From: Lasley, Timothy G
Sent: Thursday, July 19, 2018 10:01 AM
To: 'jenniferfeist@murray-enterprises.com'; 'adavies@williamsmullen.com'
Cc: Werner, Jeffrey B; Mess, Camie
Subject: BAR Actions - July 17, 2018 - 815 East High Street

BAR 18-07-03

815 East High Street; Tax Parcel 530197000, 530196000, 530195000, 530194100, 530198000, 530199000, 530200000, 530201000, 530202000

TARLETON OAK
Tarleton Oak, LLC

Pedestrian Path Elevation

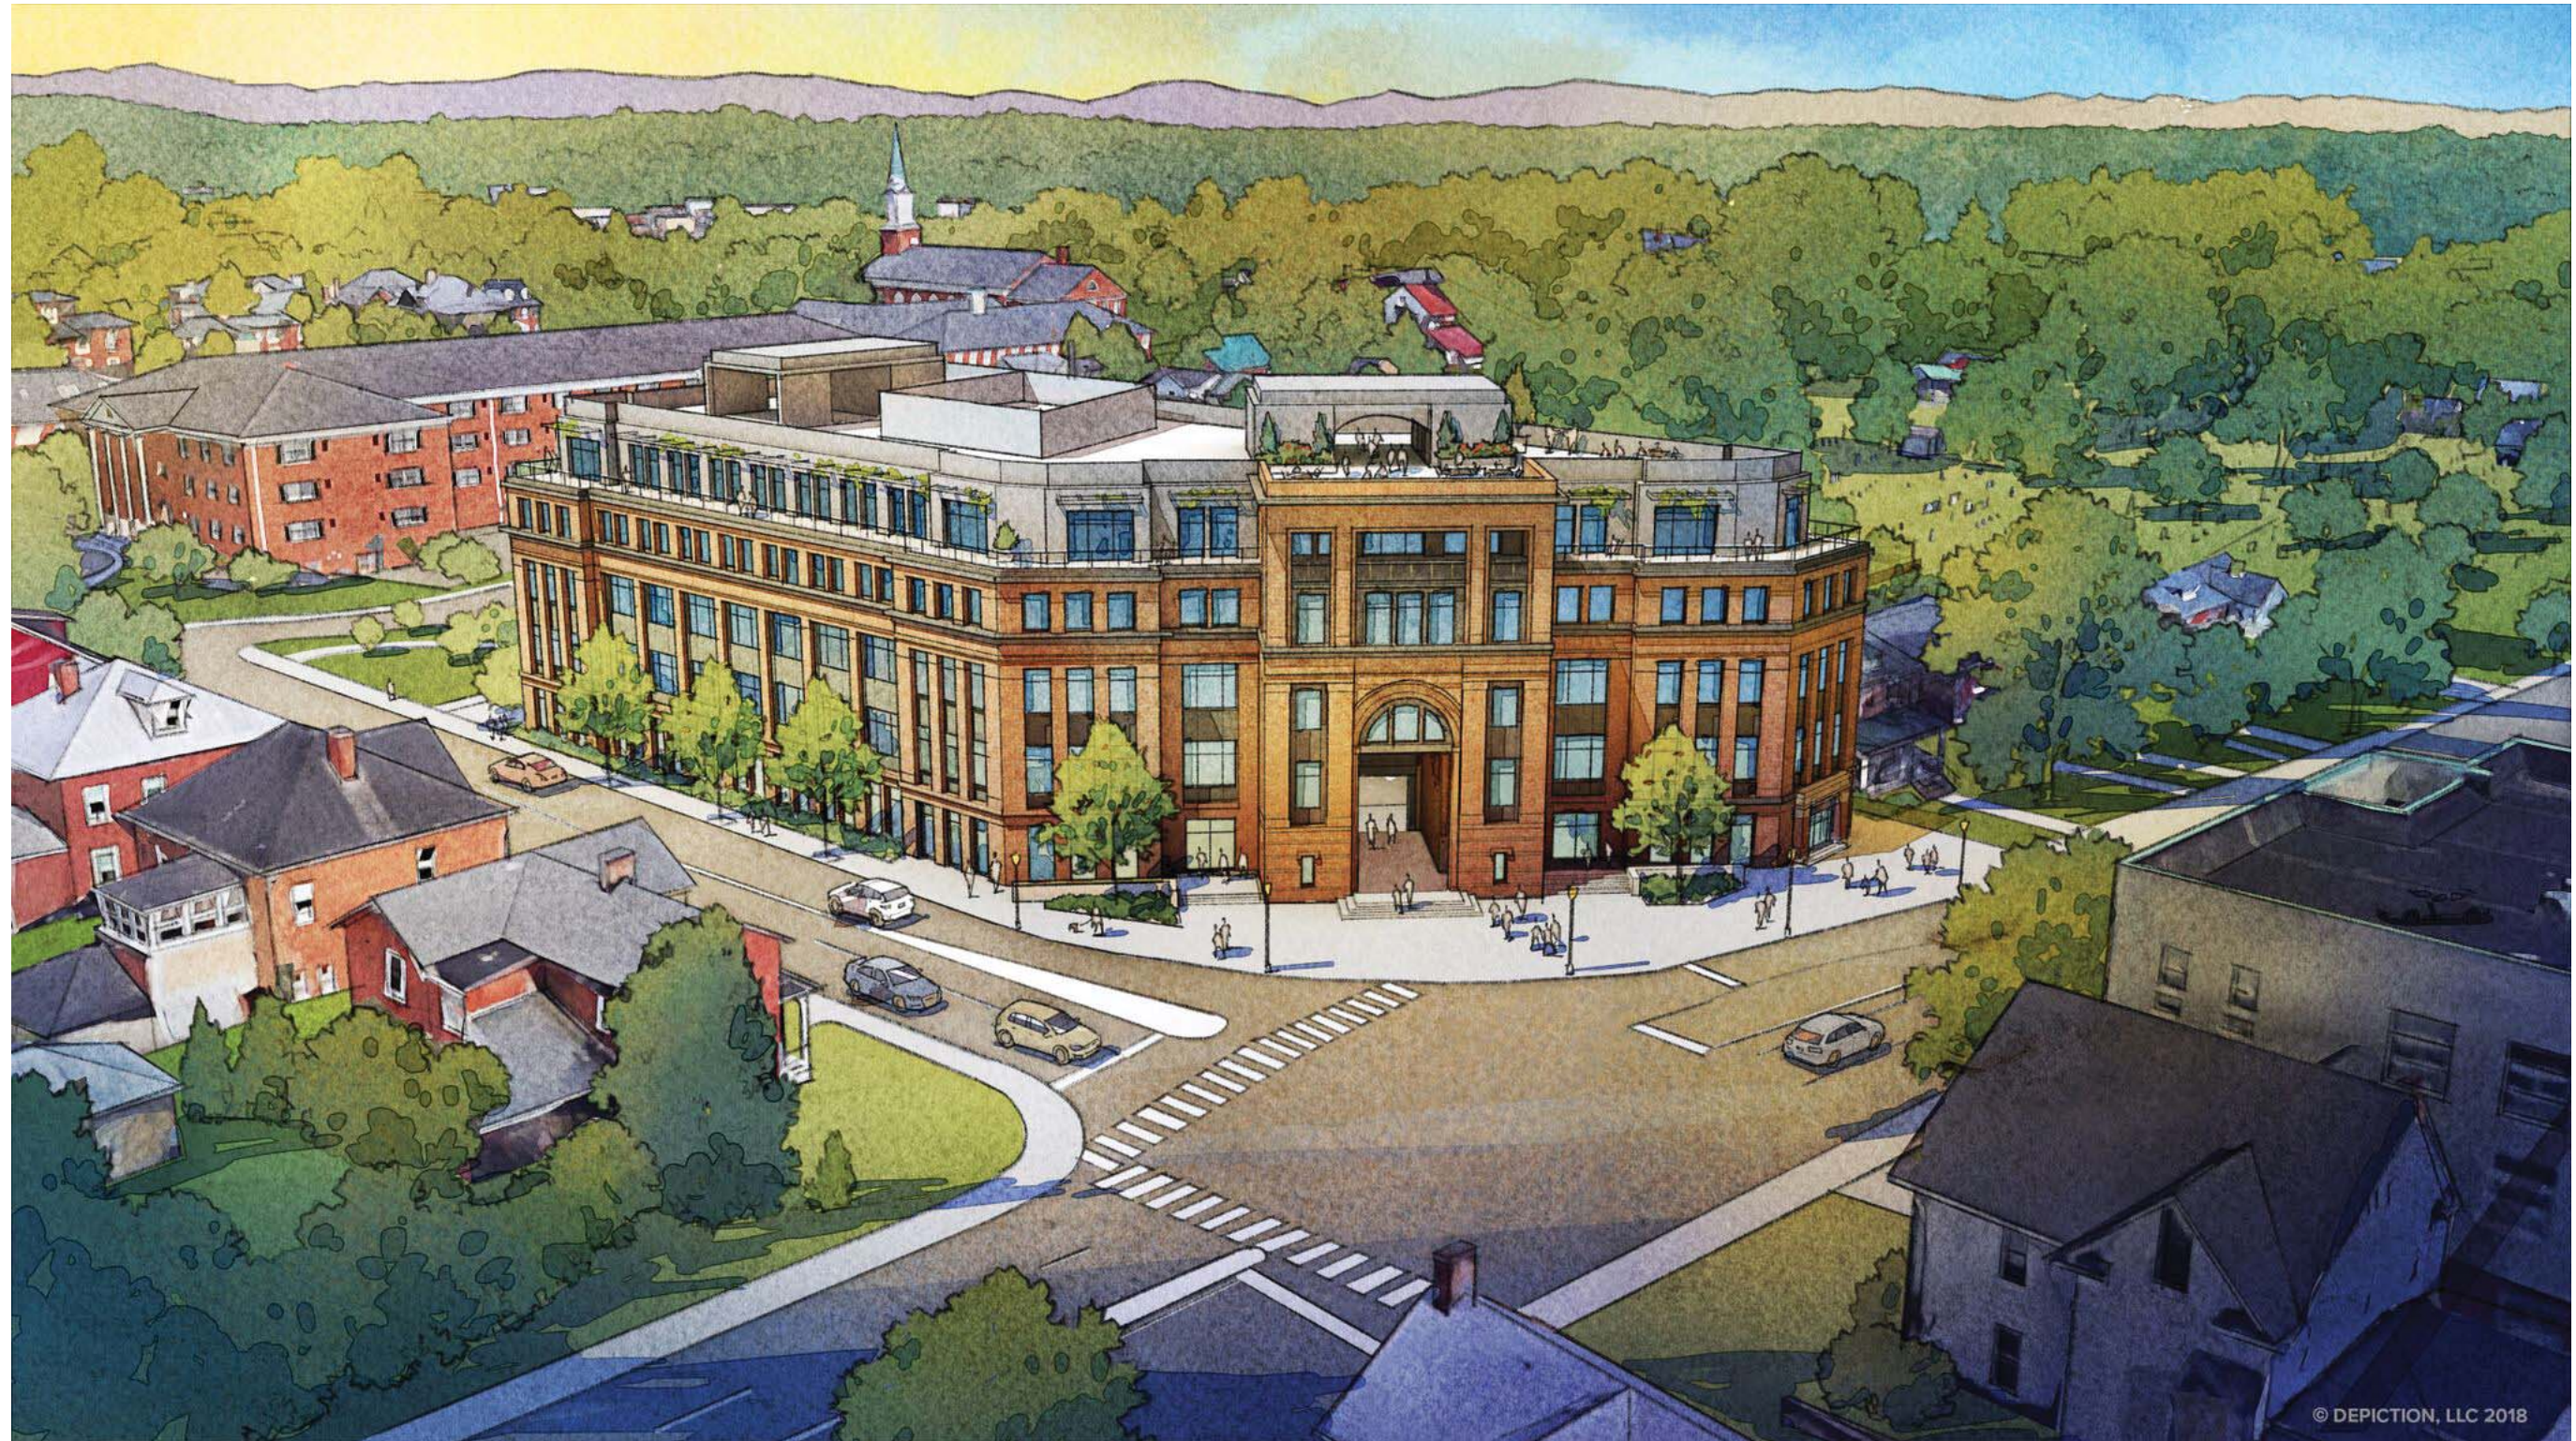
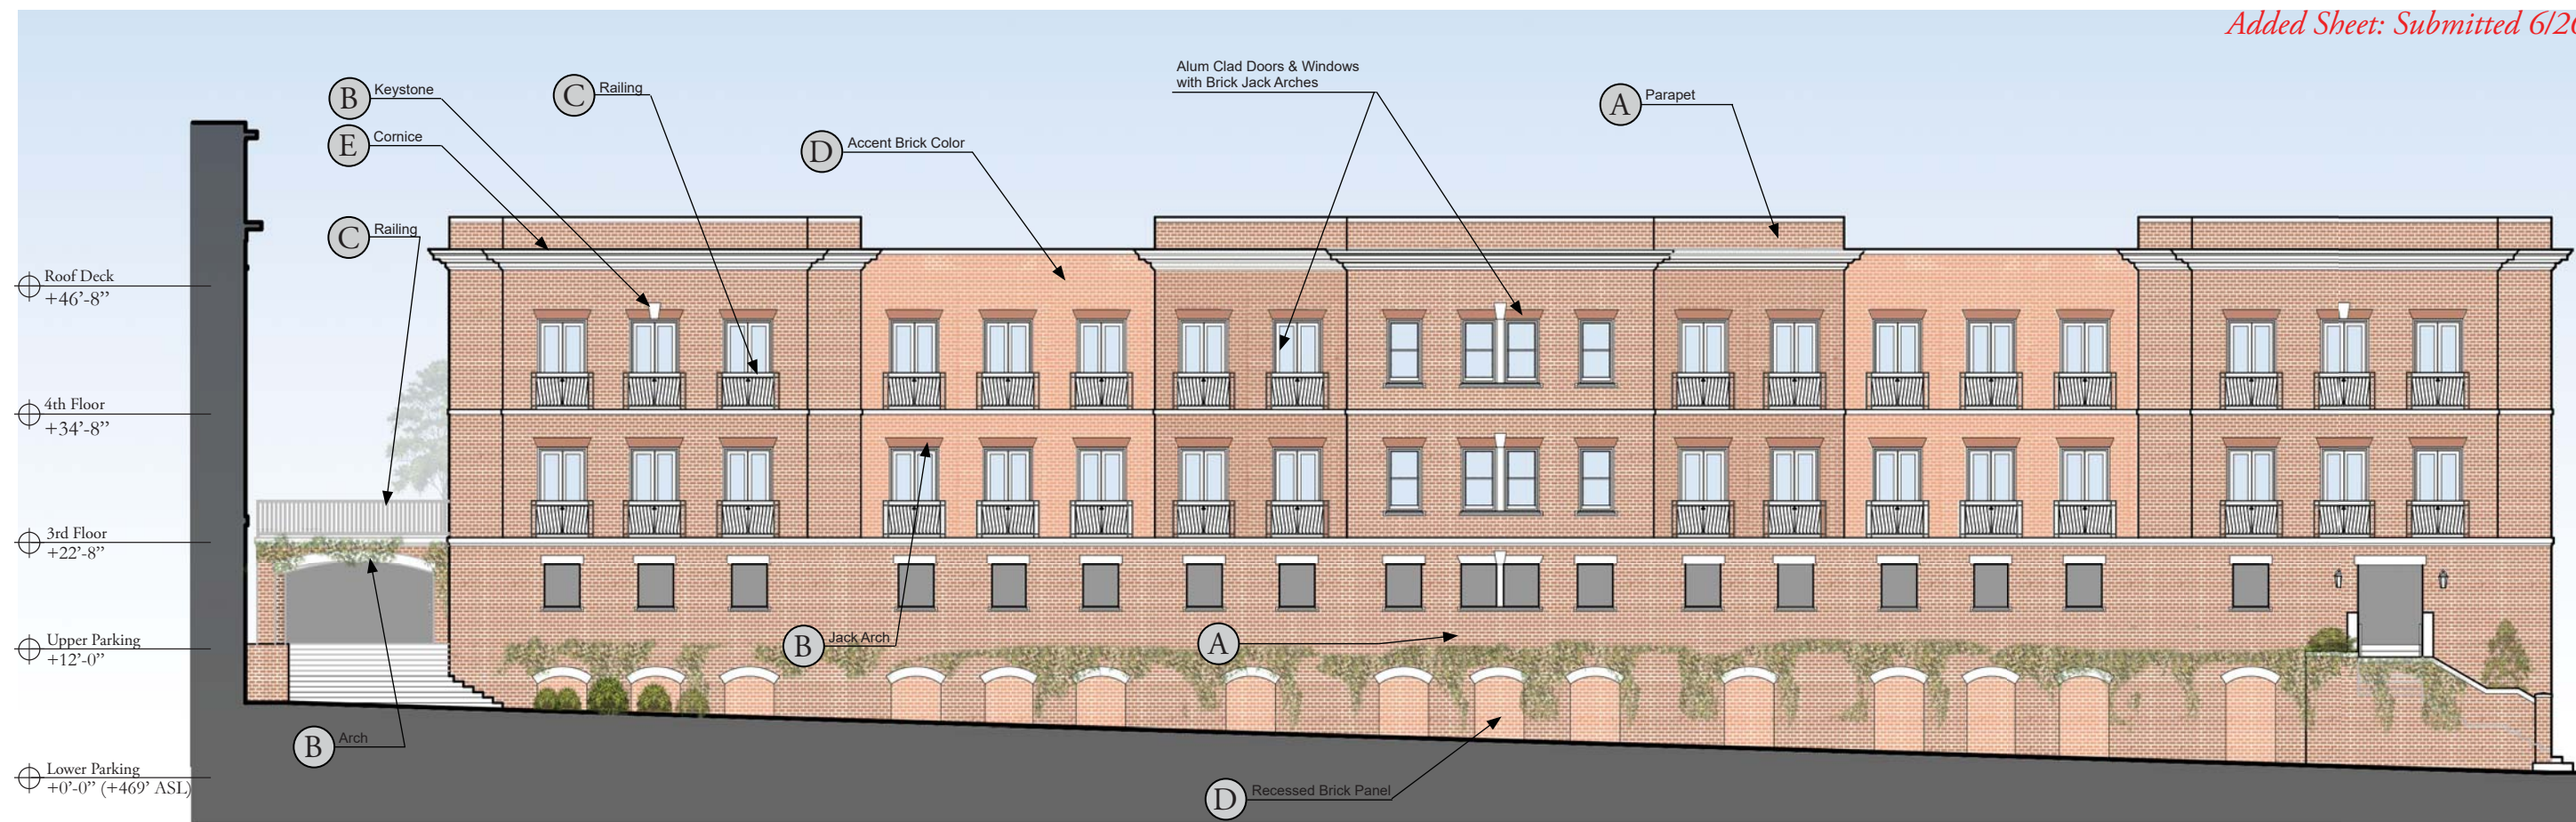
- At the NE corner, address the height of the water table band [from where the grade drops at the arched opening on Maple Street, continuing east and around the corner onto the east elevation]. (Pages 15 revised and 18.)

- At the upper floor window arches, the keystones appear random. (Pages 12 revised, 14 revised, and 18.)
- Either revise the accent brick to produce more contrast (for example, use a darker brick) or provide a design narrative to support using the one presented [on July 17]. (Pages 12 revised, 14 revised, and 18.)

- Add vegetation along the walls on either side of the pedestrian walk between the back of the five houses on Lexington Avenue and the east facade of the parking/residential structure. (Pages 9 revised, 13 revised and 18.)

Staff is generally supportive of the proposed design and materials palette, however the BAR should discuss the appropriateness of the design, materials, massing and height of the two story residential, particularly in relation to the adjacent houses on Lexington Avenue. Clarification is needed on the nature of the wall openings shown at the upper parking level (see sheets 15 revised and 18.)
